New Gen III Cool Fuel Module

All MerCruiser sterndrive and inboard engines equipped with Gen III cool fuel systems.

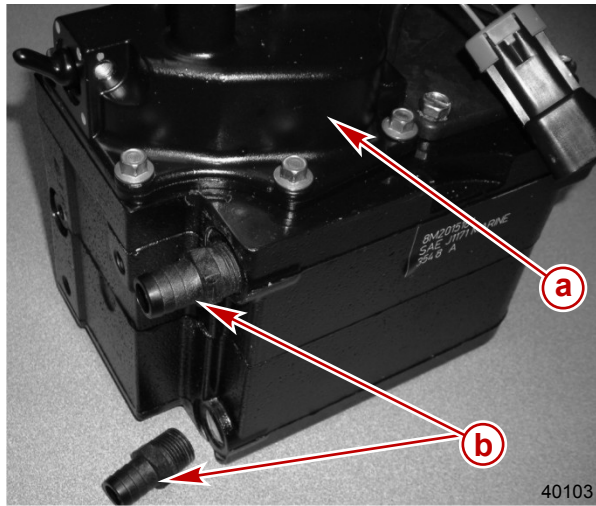
A new Gen III cool fuel module is being introduced to replace the existing Gen III module. Engines with serial numbers above the range listed are equipped with the new module from the factory. The primary difference between the designs is the method of connecting the cooling water hoses to the module. Refer to the Mercury Electronic Parts Catalog (EPC) for replacement modules for engines with serial numbers above the ranges listed.

The new style module will replace any older style module for service needs. In order to use the new module on earlier applications, the cooling water hoses and various fittings must be replaced. Kits are available to accommodate the various possible hose configurations. Order the Gen III Cool Fuel Module with pumps and filter, or a lower module housing only along with the proper hose kit for installation. One module and one kit are required per engine.

Replacement kits	
Complete Gen III module with pumps and filter	864650A13
Lower Gen III module housing (no pumps or filter)	864650A14
Two bib hose kit	865317T02
Three bib hose kit	865208T02

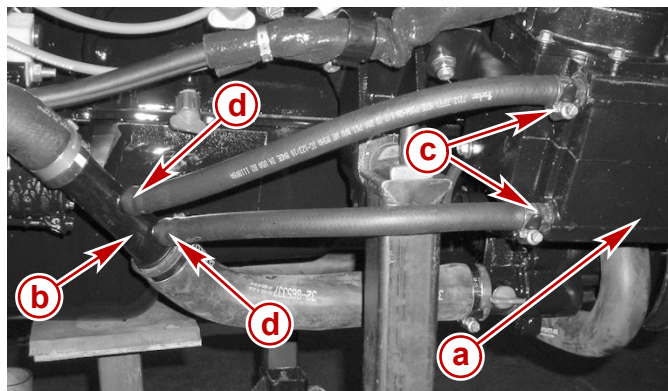
Threaded hose barb fittings are supplied with the new Gen III cool fuel module. The threads on the barbed hose fittings and the threaded bore must be coated with Perfect Seal. Any removal of the fitting will require resealing the threads. Refer to the instruction sheet with the module for additional installation information.

The hose connections at the module must be secured with hose clamps. The hose connections at the restrictor are friction fit and are preassembled at the factory.
